WORDING FOR AGENDA ITEM: Courthouse- South East Windows Needing Emergency Repair

RE: Woodbury County Courthouse Courtroom Windows, Emergency Action

WINDOW STUDY

SOUTHEAST COURTROOM 203
WOODBURY COUNTY COURTHOUSE / SIOUX CITY, IOWA

Steel Sash at Art Glass Windows – Views of Deteriorated Paint System & Surface Rust

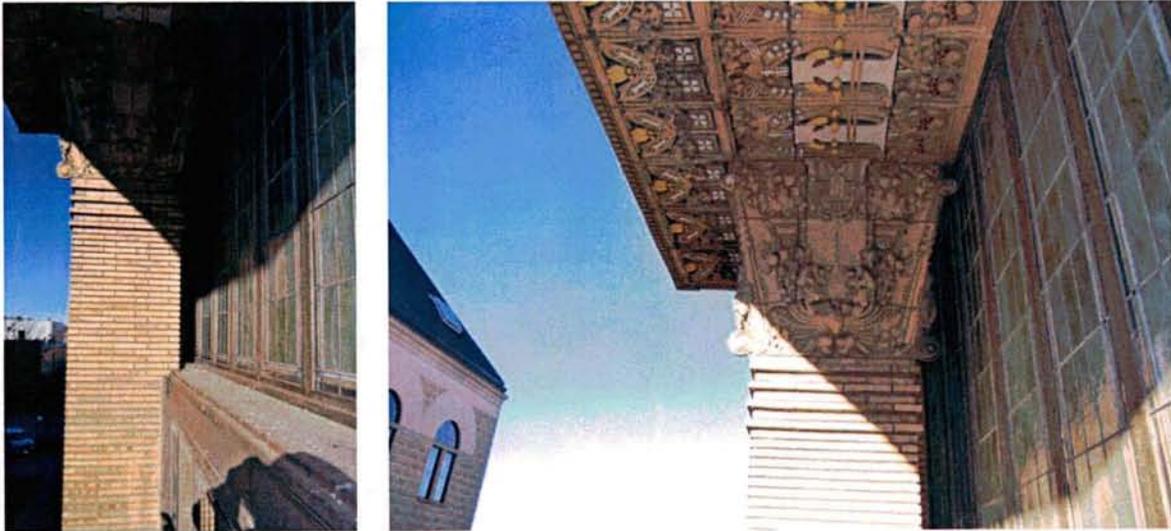
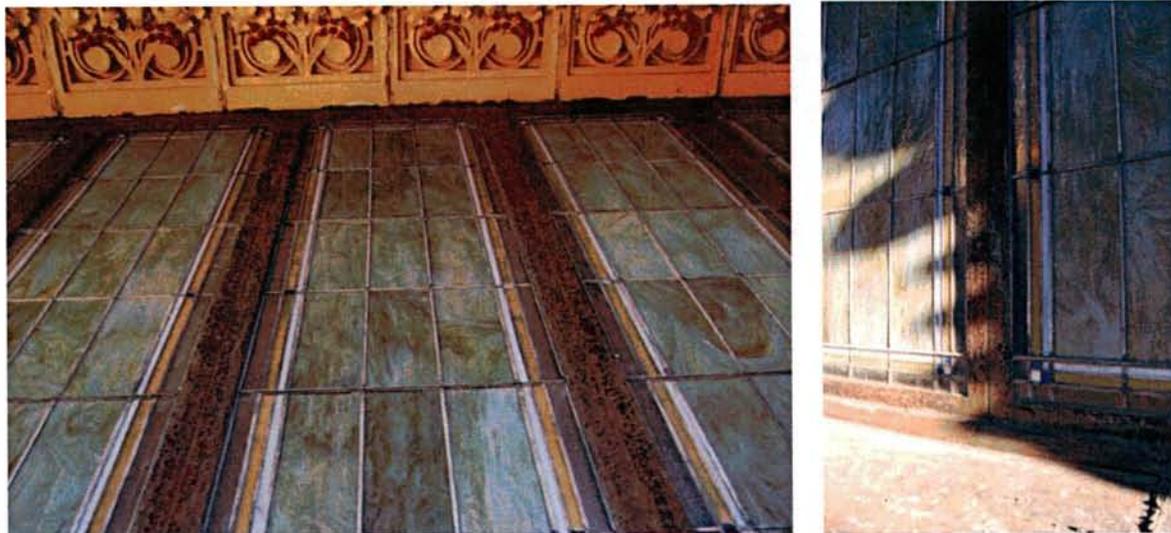
Condition: The photos below indicate the general condition of the Steel Sash containing the Art Glass at the Window Assembly. The portion of the paint system, exposed to the exterior, protecting the steel material, has generally deteriorated, exposing the steel, which exhibits surface rust. Sealants are missing, hardened or cracked in various locations.

Recommendation: that the remnants of the exterior paint system be removed; the surface rust be removed or otherwise neutralized; a new paint system be installed. Provide an entirely new sealant system.

During this procedure, the steel sash pieces shall be closely examined for deterioration, beyond 'surface' rust condition, and appropriate repairs be made at that time. It is not expected that removal of the existing steel sash will be required.

*View along top of Steel Transom – Looking West
(Note bird droppings and various areas of surface rust)*

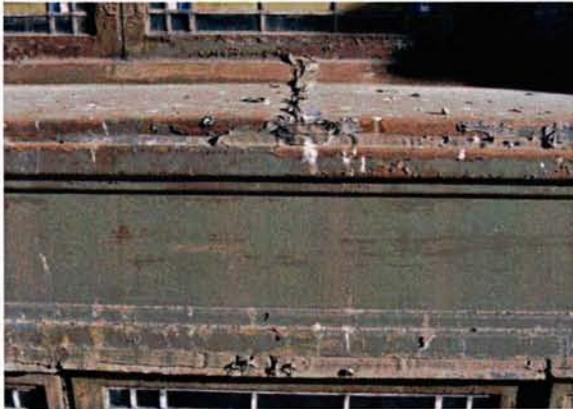
General Condition: The photos below indicate the general condition of the Steel Transom. The paint system, protecting the steel material, has generally deteriorated, exposing the steel, which exhibits surface rust. The top surface of the Transom is covered with grime and bird droppings. Sealants are missing, hardened or cracked in various locations. There are various maintenance repairs that have been made over time that require attention.

Recommendation: that the existing paint system be removed, along with the grime and bird droppings; the surface rust be removed or otherwise neutralized; a new paint system be installed. Provide an entirely new sealant system.

Steel Transom – Bowed Shape

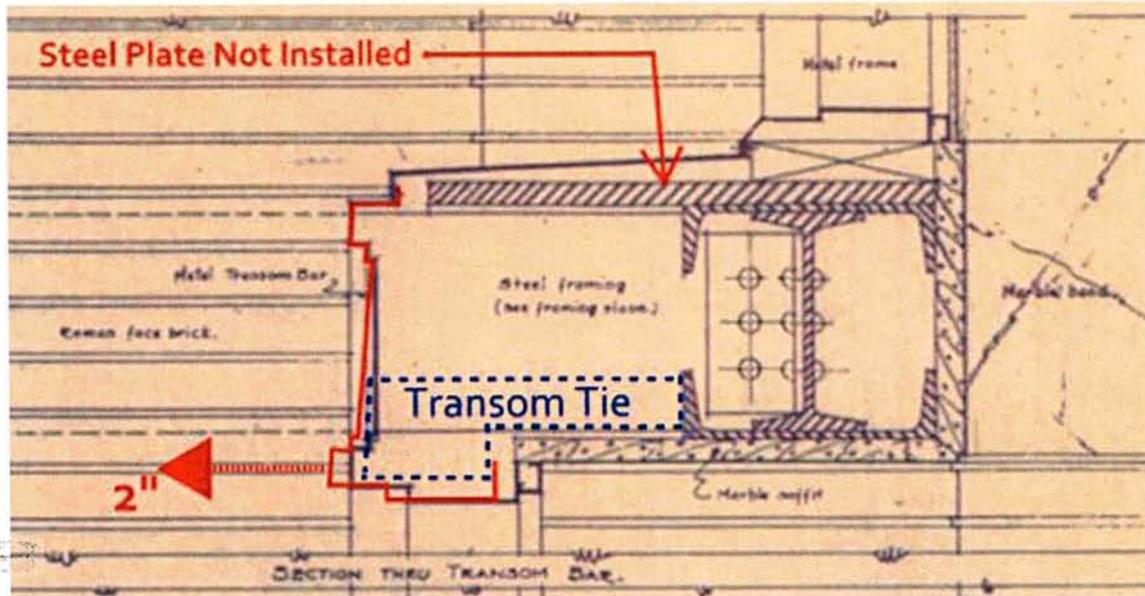
Condition at Bowed Shape: the position of the east and west ends of the steel transom, (in relation to the masonry piers at either side of the central portion of the window assembly), seems to be the same as when constructed in 1916-18; however, the center of the steel transom has bowed out, away from the interior of the building, by 2 inches, (see diagram, below).

This movement has caused a gap between the steel transom metal, (which has moved), and the marble soffit material, (which has not moved).

As the movement is most severe at the window (southeast) that has received the most sun over the years, it is conjectured that the beam & transom elongate with the heat and bow outward. When conditions cool, the beam straightens out, but the transom, which is tied to the windows below, stops slightly short of straight. During the 100 years life of the building, this slightly less than straight recovery has permanently warped the shape of the transom.

Recommendations: rather than dis-assemble the entire window assembly and replace the transom material with new, straight material, our opinion is that tying the vertical face of the transom in place, to contain the transom and prevent additional bowing, seems the logical alternative.

Steel Channel at Lower Window Jamb & Steel Transom – West End of Center Windows

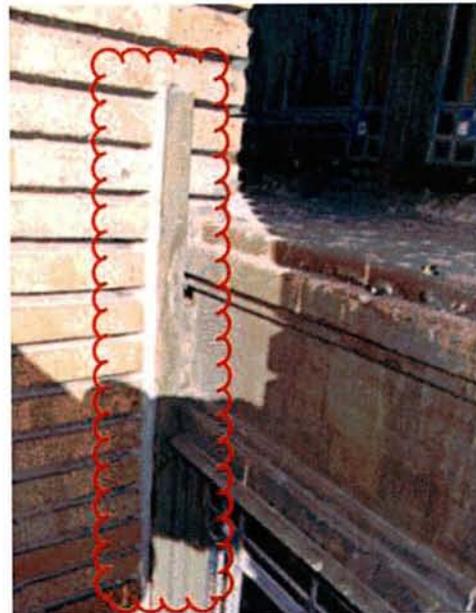
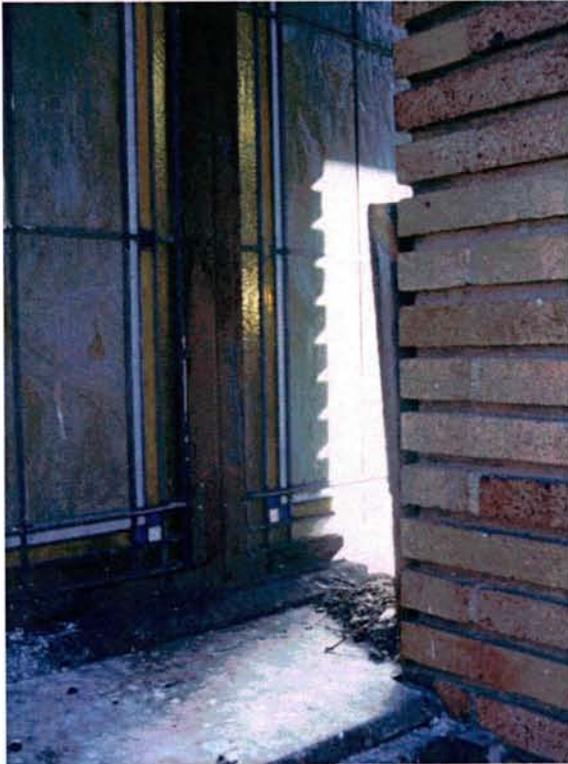
General Condition – 'Extra' Steel Channels: The photos below indicate vertical steel channels that have been installed at locations where the lower (clear glass) windows meet masonry walls; this occurs only at the Southeast Courtroom Windows. The vertical edges of the channels are caulked against the masonry and the window sash; the open, upper and lower ends of the channels have been filled with sealant; some of which is missing.

It is assumed that gaps between the masonry and window sash developed that were too wide to effectively receive (and hold) sealants; and that the channels were applied to cover the gaps.

Recommendation: that the channels be removed and a less obvious means be developed to extend the metal window sash. Provide an entirely new sealant system.

View of Fixed & Operating Sash - Note the deteriorated portions of the Fixed Window Sills

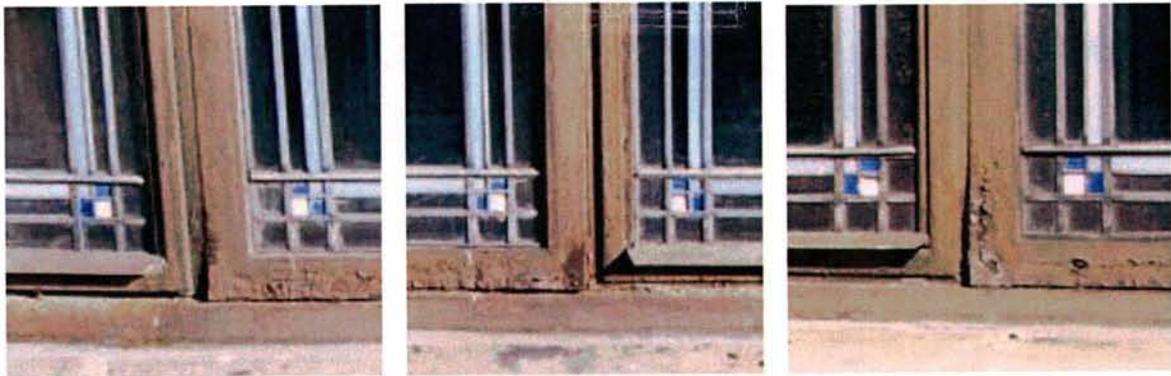
Condition: The portion of the paint system, exposed to the exterior, protecting the steel material, has generally deteriorated, exposing the steel, which exhibits surface rust at most locations. Sealants are missing, hardened or cracked in various locations.

In addition, at the lower corners of the some of the fixed windows, the steel is deteriorated to the extent that it is flaking in layers from long-term rusting.

Recommendation: that the remnants of the existing exterior paint system be removed; the surface rust be removed or otherwise neutralized; a new paint system be installed. Provide an entirely new sealant system.

During this procedure, all steel sash pieces shall be closely examined for deterioration, beyond 'surface' rust condition, and appropriate repairs be made at that time.

At the bottom portions (sills) of these windows, methods shall be investigated to make repairs 'in place', if at all possible; however, it is a possibility that removal of the existing steel sash will be required to affect repairs.

Views of the Marble Soffit where it meets the (blue) metal trim at the top of the Lower Windows.

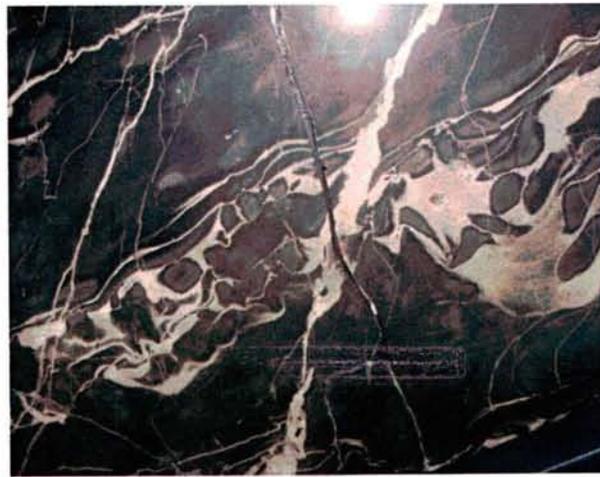
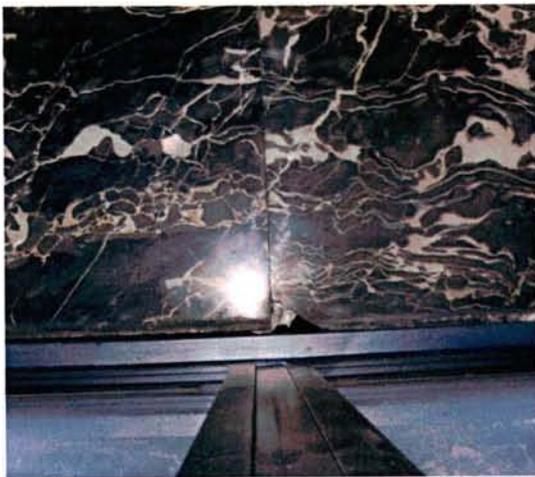
An earlier location of the face of the window trim is thought to be the 'brown' paint line, on the surface of the marble in both photos, (above), caused by an earlier painting of the windows. The current gap is approximately ½ to ¾ inch in the photos.

Clip Angle Suggestion: a Clip Angle, such as the one shown on the diagram on the previous page, could be screw attached to the trim channel at the window head, (or replace the trim channel), to cover the gaps at windows having that condition. Paint to match window color.

View of Underside of Transom, looking East, at area where Marble Soffit is missing.

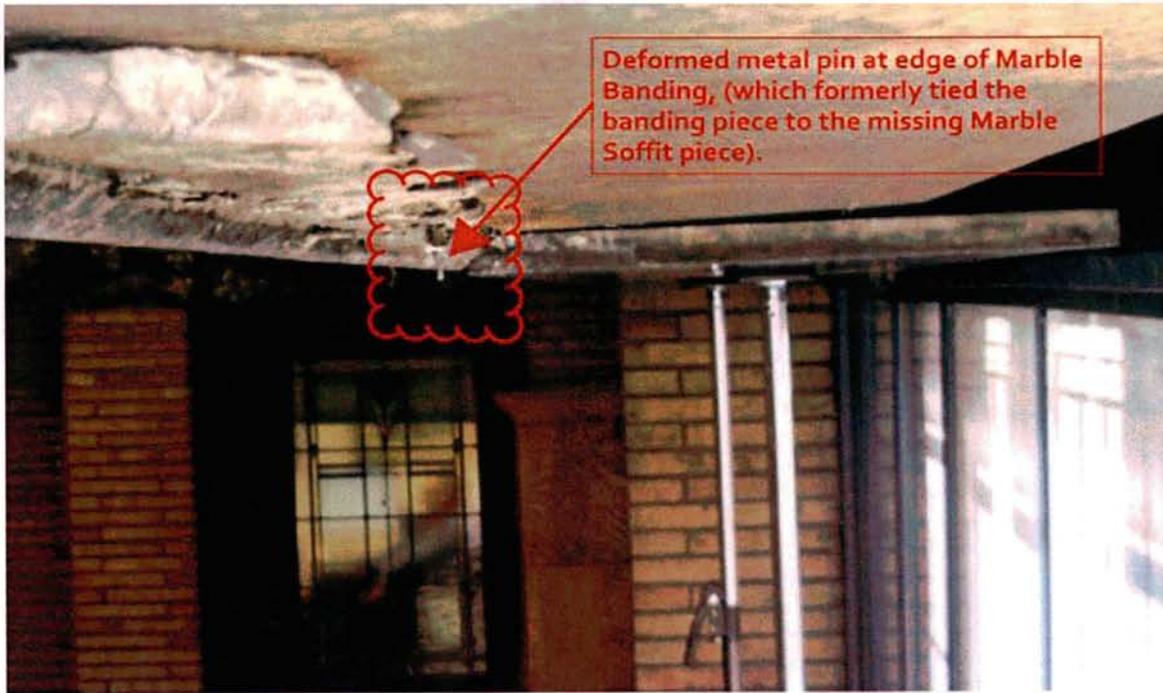
These supports failed at the missing piece of marble soffit, allowing it to fall from its place.

There is no certain means to determine what, if any, damage has occurred to the existing support wiring at the remaining soffit pieces; this is an unknown. To determine the actual condition, 'destructive' testing, (i.e. removing the marble pieces to determine the condition of the support wires and the integrity of the marble at the wire support points), would be necessary. And, as removal of the marble, under these conditions, would demolish it, the result effectively becomes entire removal and replacement of the marblework.

Recommendation: provide a matching replacement for the marble soffit piece that is missing. Design a means to secure it in place that is seamless with adjacent work.

Install a continuous clip angle, (as noted at Clip Angle Suggestion, above), to provide additional support for the window edge of the marble soffit pieces

Regularly monitor the various marble pieces at transoms to discern movement.
